NEW COUNTRY CLUB ESTATES SUBDIVISION, RESUBDIVISION OF LOTS 64 & 65, SEVENTH UNIT

Engineering Comments: FINAL PLAT COMMENTS (should be addressed prior to submitting the FINAL PLAT for review and/or signature by the City Engineer):

APPLICATION NUMBER 3 DATE June 20, 2019
 APPLICANT New Country Club Estates, Resubdivision of Lots 64 & 65, Seventh Unit
 REQUEST Subdivision

DETAIL SITE PLAN

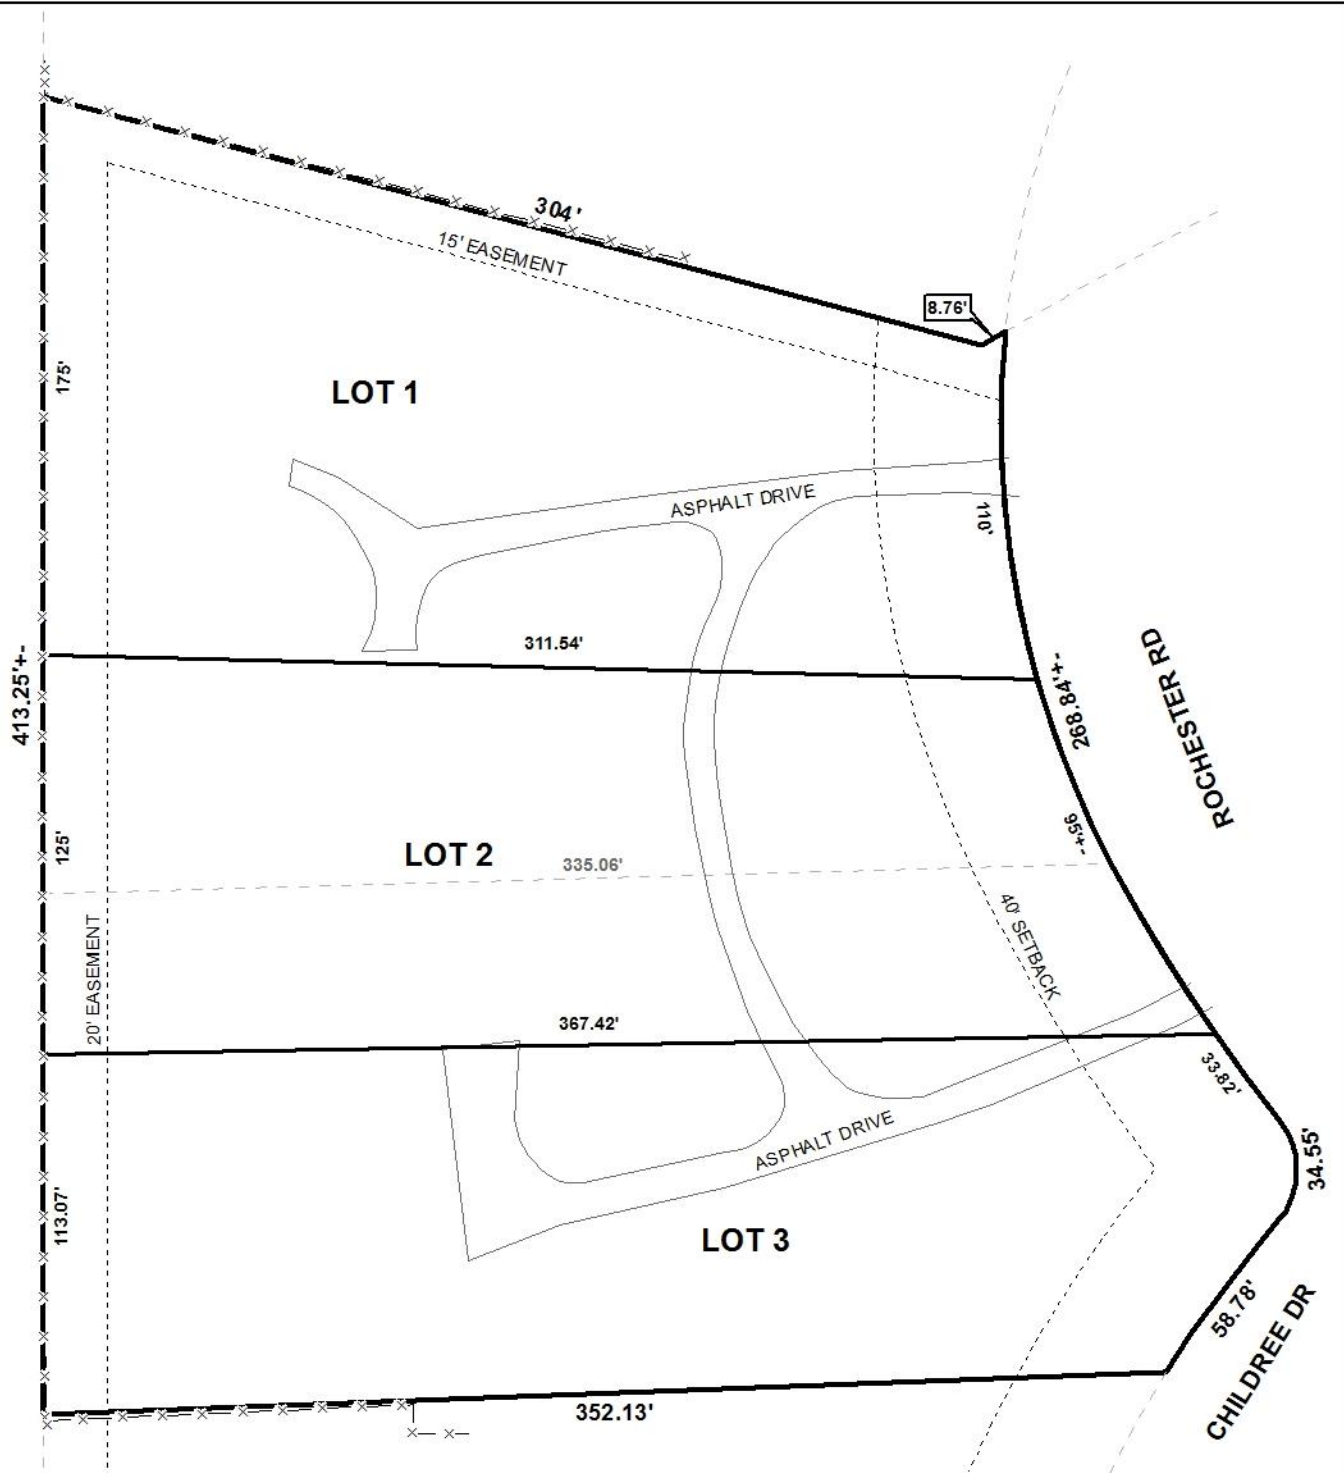
The proposed lots front Rochester Road and Childree Drive, both minor streets requiring a 50' right-of-way width. The preliminary plat does not provide the right of way widths. If approved, the Final plat should be revised to provide the appropriate right-of-way width.

A 40-foot minimum building setback is illustrated on the preliminary plat. If approved, the 40-foot minimum building setback should be retained on the Final Plat.

It should be noted that there is an existing 15' bridle path easement along the northern perimeter of Lot 1 and a 20' bridle path easement along the western perimeter of Lots 1, 2 and 3.

The proposed lots each exceed the 7,200 square foot minimum lot size requirement for lots served by public water and sanitary sewer systems. The preliminary plat provides the lot sizes for each lot in square feet and acres. If approved, the lot size information should be retained on the Final Plat.

- 1) Labeling of the existing right-of-way of Rochester Road and Childree Drive;
- 2) Retention of the 40' minimum building setback line along Rochester Road and Childree;

- 3) Retention of lot size information in both square feet and acres;
- 4) Placement of a note stating that no structure shall be erected in any drainage and utility easement;
